AMENDMENT OF SOLICITATION/MODIFICATION OF CONTRACT				1. CONTRACT ID CODE J		PAGE OF PAGES 1 4	
2. AMENDMENT/MODIFICATION NO. 0003		3. EFFECTIVE DATE 17-Jun-2004		4. REQUISITION/PURCHASE REQ. NO.		5. PROJECT NO.(If applicable)

CHANGES IN PLANS AND SPECS

RABIA E BALAKH HOSPITAL
SOLICITATION NO:
W97PM44-004

BUILDING B
FIRST FLOOR

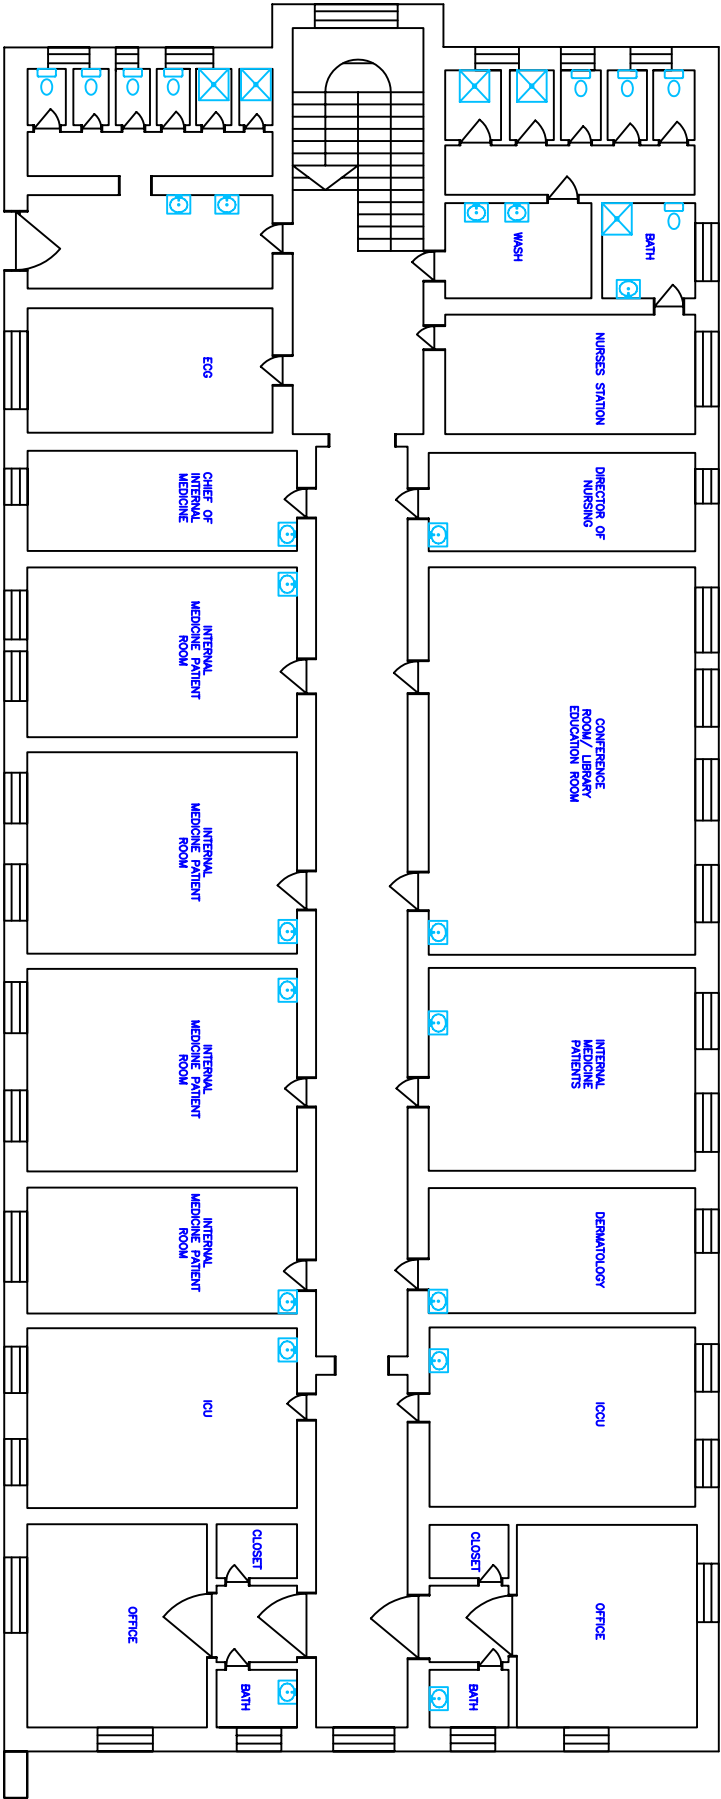
5.3 Bid Schedule Item 0004-Install lead shielding in X-ray room on first floor of building B. Install lead shielding to the height of 2.4 meters with sheet lead 6 mm thick on the x-ray room walls. Lead shielding should also be installed on the door and door frame and covered with plaster upon completion.
8. In paragraph 5.0 Optional Bid Scope of Work, **ADD:**

5.5 Bid Schedule Item 0006-Install AC split packs in the two pharmaceutical storage rooms on the first floor of Building B. The wiring for the AC split pack unit shall meet international standards for grounding, and the AC

split pack units shall meet international standards for fresh air exchange. The operating noise level shall not exceed 45 decibels.

BUILDING C
FIRST FLOOR

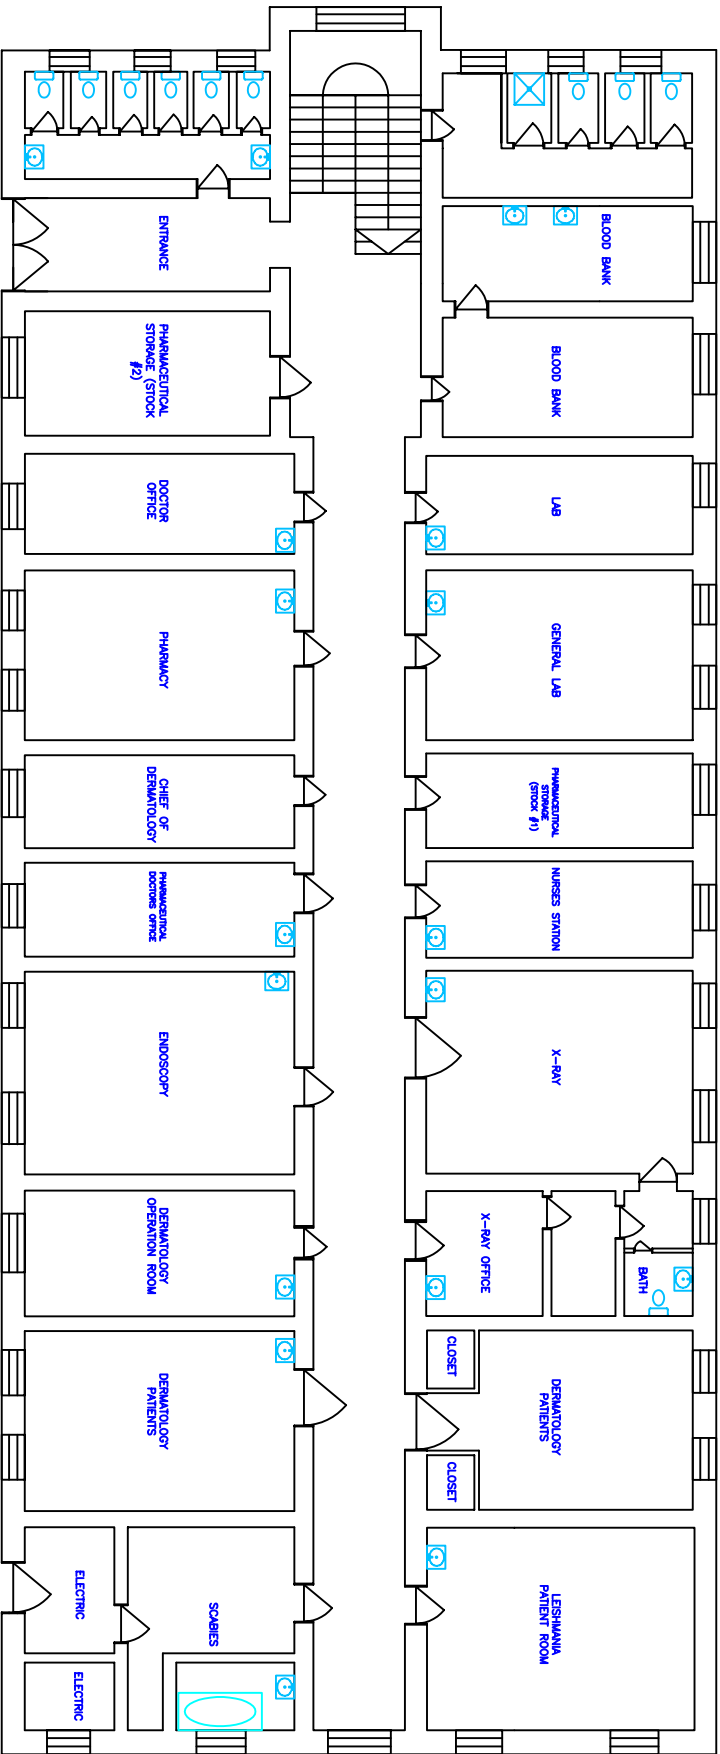
3. In paragraph 2.8, **DELETE** the entire paragraph, and **REPLACE** with: Not Used
4. In paragraph 2.10, **DELETE** the entire paragraph, and **REPLACE** with: Secure the several propane tanks located outside behind the kitchen area of Building C by adding security bars and gate(s) to the propane tank storage area.
